**WHEELING PLAN COMMISSION
THURSDAY, FEBRUARY 14, 2019 6:30 P.M.**

REQUEST FOR PLAN COMMISSION ACTION
STAFF PROJECT REVIEW

RE: **Docket No. PC 18-19**
JV Global Services LLC
150 Abbott Drive
Minor Change to Approved Site Plan

RE: **Wolf Road Industrial – Panattoni Development**
1020, 1022, 1026, 1027, and 1030 Carol Avenue; 37 Kerry
Lane; 1020 Plant Road; and 1032 S. Wolf Road
Docket No. 2019-1
Rezoning from the R-1A Single-Family Residential and I-1
Light Industrial to I-2 Limited Industrial District;

LINE OF SIGHT - EAST SIDE OFFICE (NORTH END)

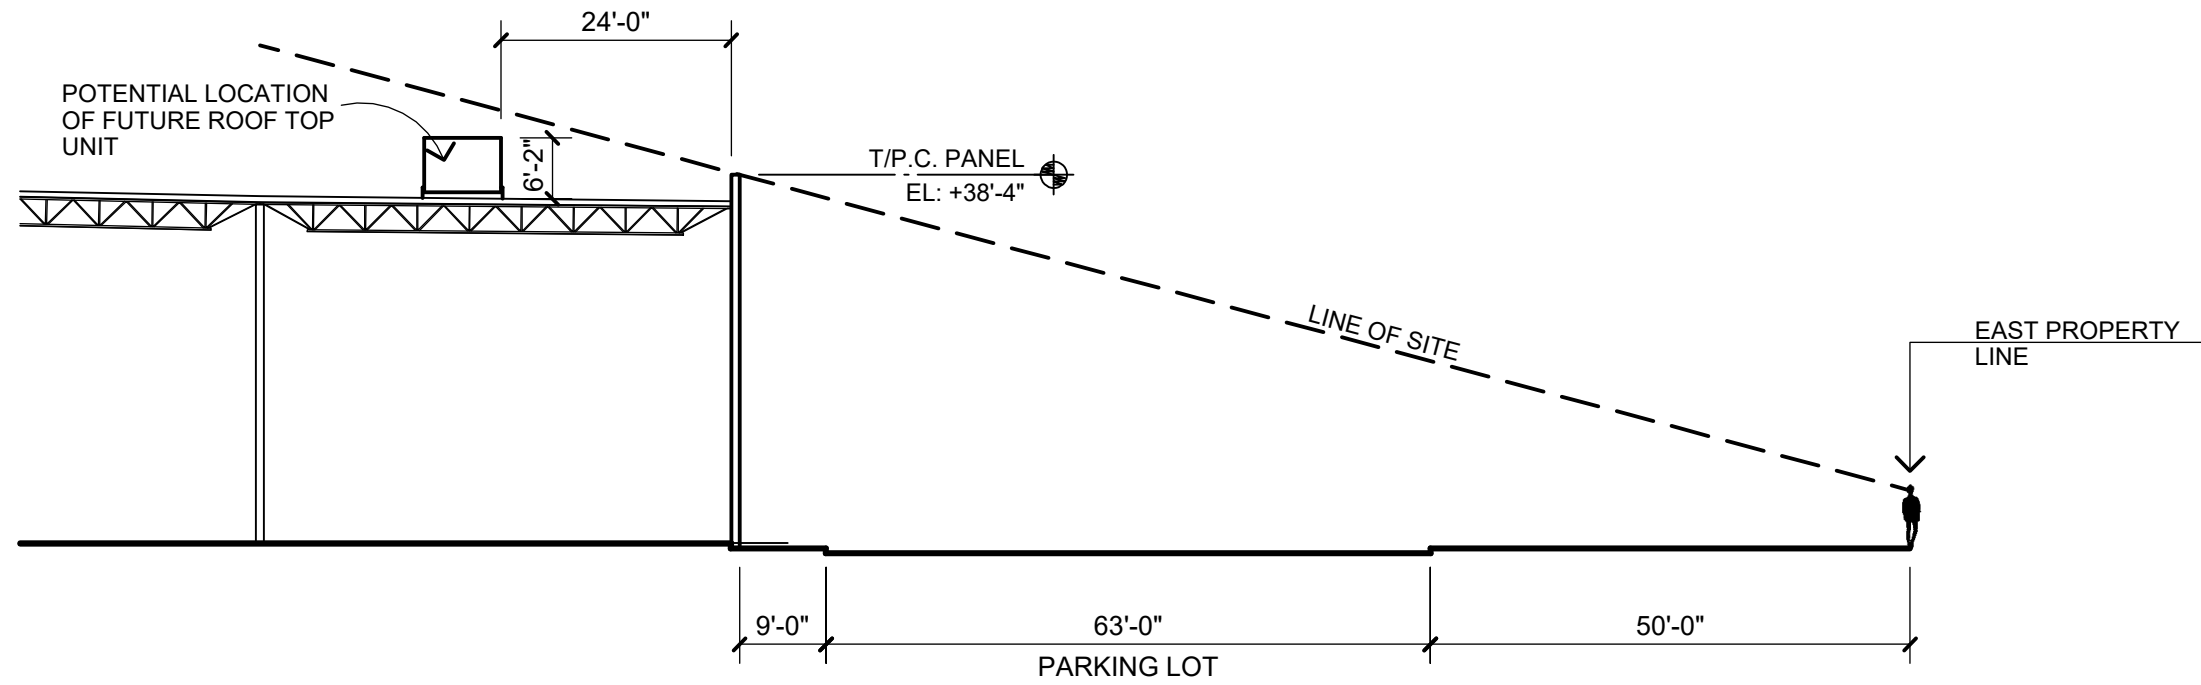
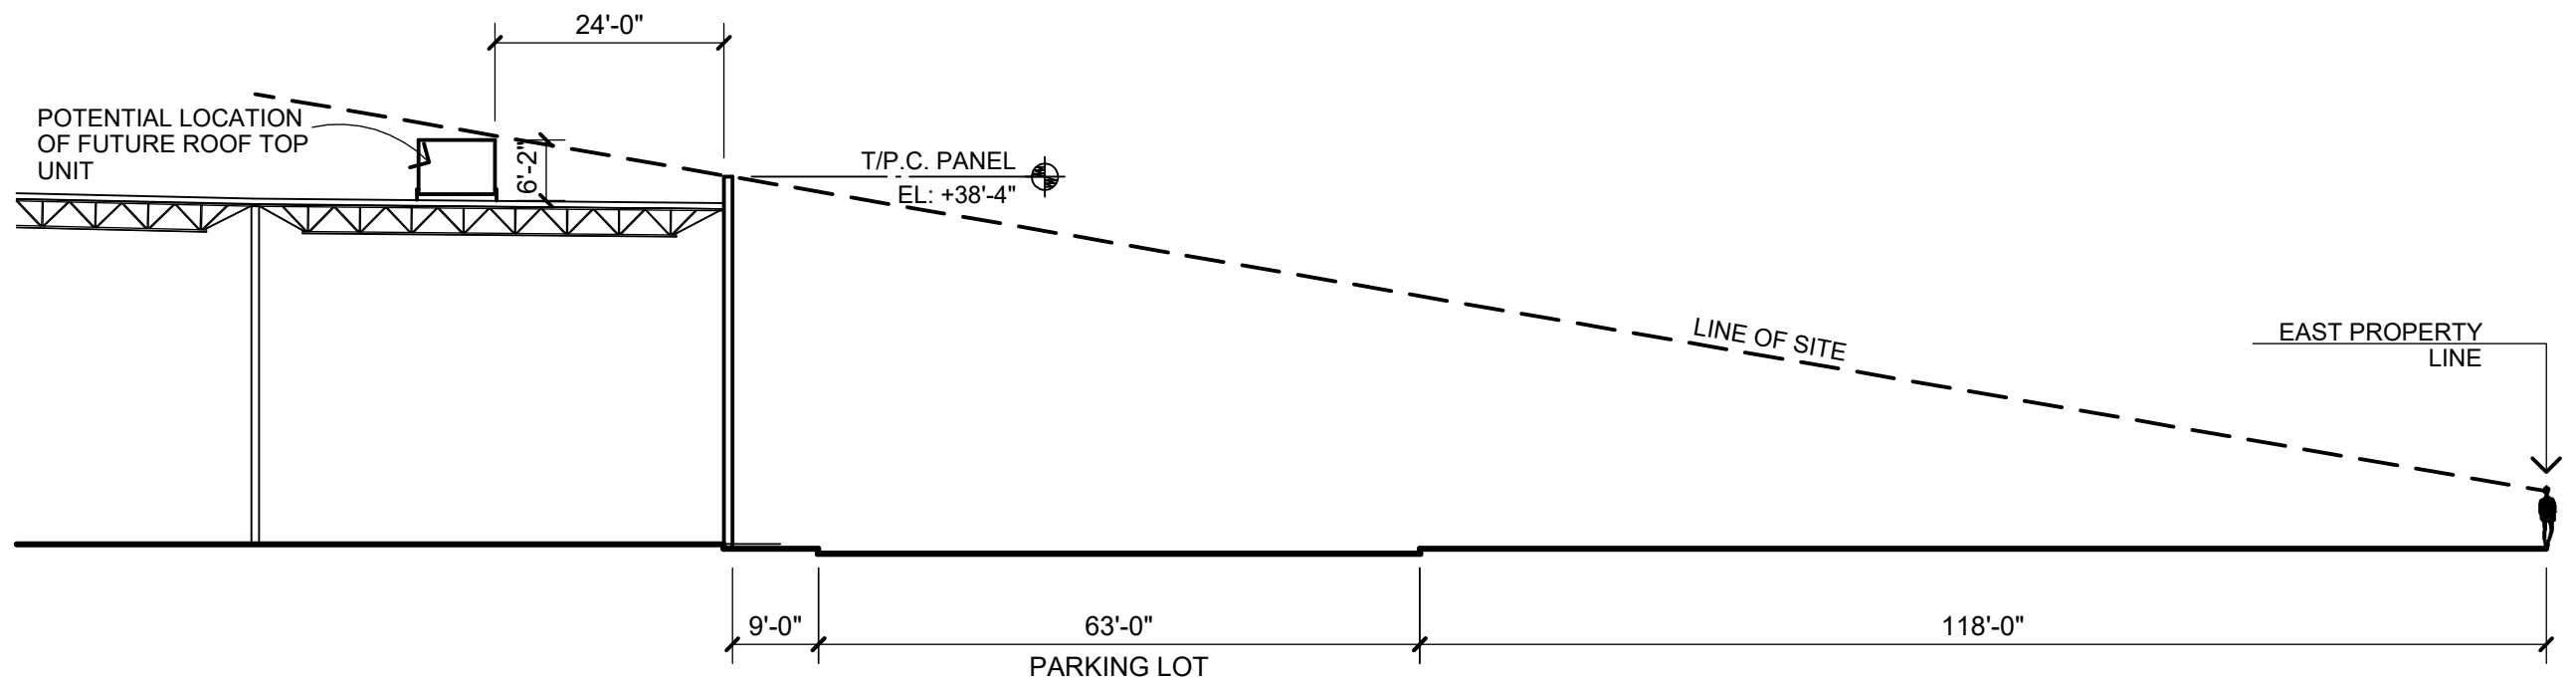
HVAC/Mechanical Components Screened: A height detail has been provided indicating the tallest rooftop units will be 6'-2". The petitioner has also provided line-of-sight diagrams to demonstrate that the roof mounted mechanical units would not be visible from various points around the site. Since the parapet walls are nominal, the roof top units would not be screened by a parapet wall. The tallest point of the proposed building is 40', which is the maximum building height permitted in the I-2 District. The Plan Commission can grant exceptions to the height limitations for necessary mechanical appurtenances and their accessory screening as part of an appearance review, if necessary.
